Product Change Notification: SYST-170WAE192

PIC18F27/47/57Q83 Silicon Errata and Data Sheet Clarifications

Description of Change:

Added silicon issues 1.1.6, 1.2.2 through 1.2.8, 1.11.1, 1.12.1, 1.13.1, 1.14.1 and 1.15.1; added DS Clarifications 2.1 through 2.13.

1.6.1. UART TXDE Signal May Go Low Before the STOP Bit Has Been Entirely Transmitted

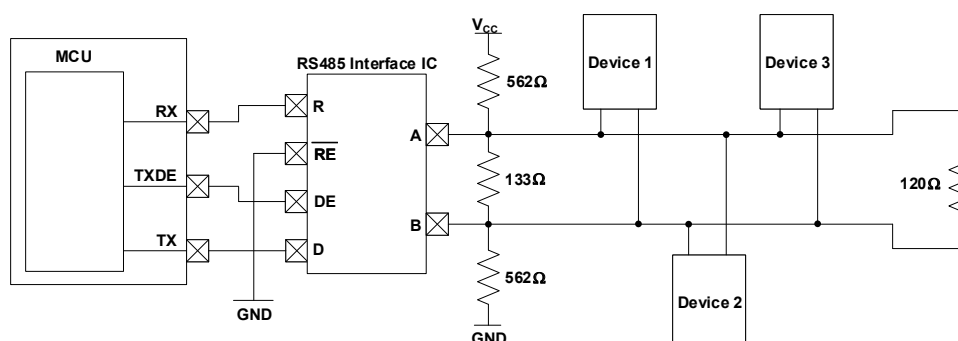
The UART Transmit Drive Enable (TXDE) signal could potentially transition into a low state before the UART Stop bit has been entirely transmitted due to the effects of parasitic capacitance on the TX line. In some applications, this could result in communication being prematurely terminated due to the TXDE signal going low before the STOP bit has had enough time to settle.

To ensure that the Stop bit settles into its final logic state before the TXDE signal transitions low, a biasing circuit can be implemented. A biasing circuit allows the TX line to either be driven high or low, rather than being left in a floating tri-state mode, where prolonged rise or fall times could lead to communication being disrupted. This bias circuit must only be implemented on one end of the serial bus, and a termination resistor must be used on the other end. The figure below shows an example of a bias circuit that can be used to achieve this.

Please note that the resistor values used in this circuit are recommendations and that the actual resistor values required may vary based on the application.

2.6. 48-Lead TQFP Package Drawing

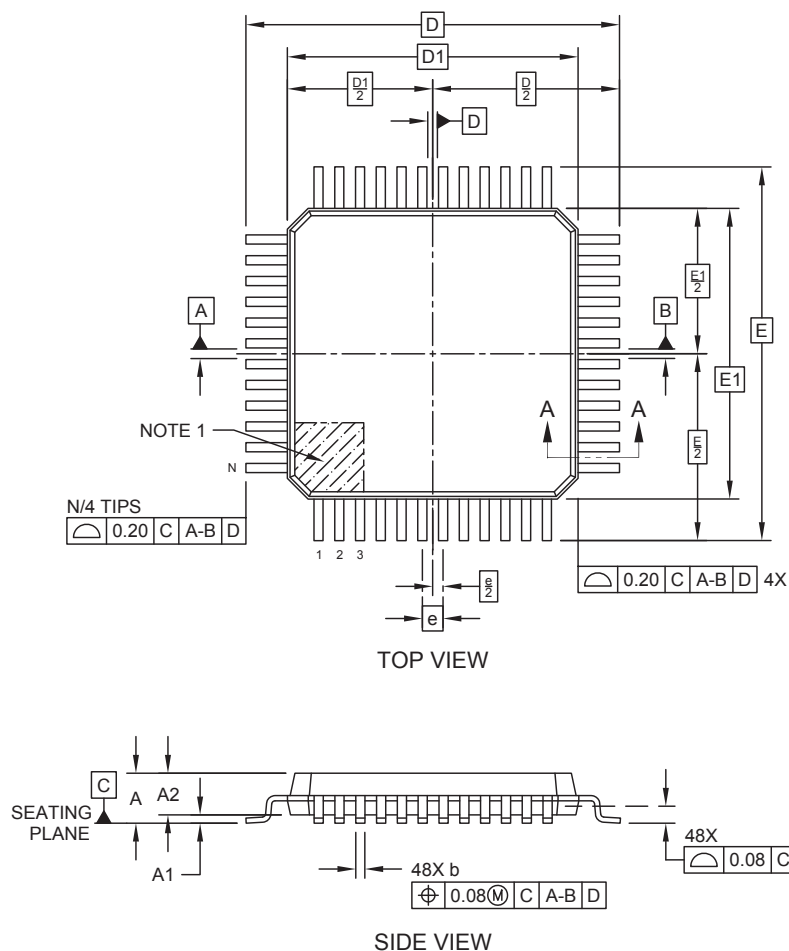
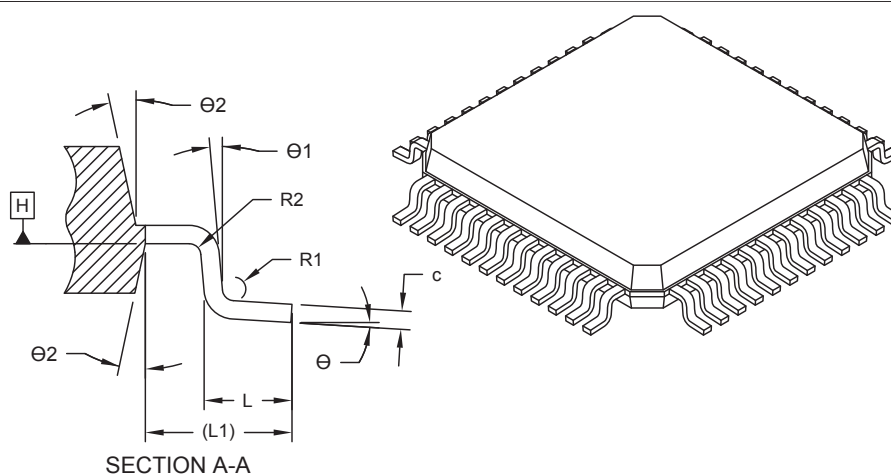
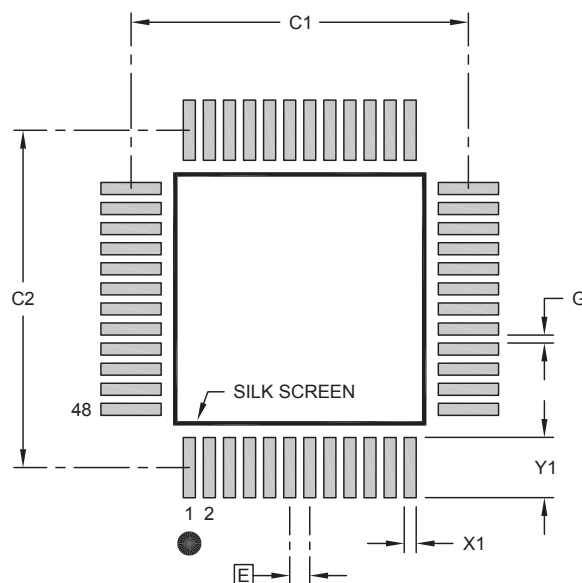
The data sheet lists the incorrect package drawing for the 48-lead TQFP package. The correct package drawings are shown below:

48-Lead Plastic Thin Quad Flatpack (Y8X) - 7x7x1.0 mm Body [TQFP]
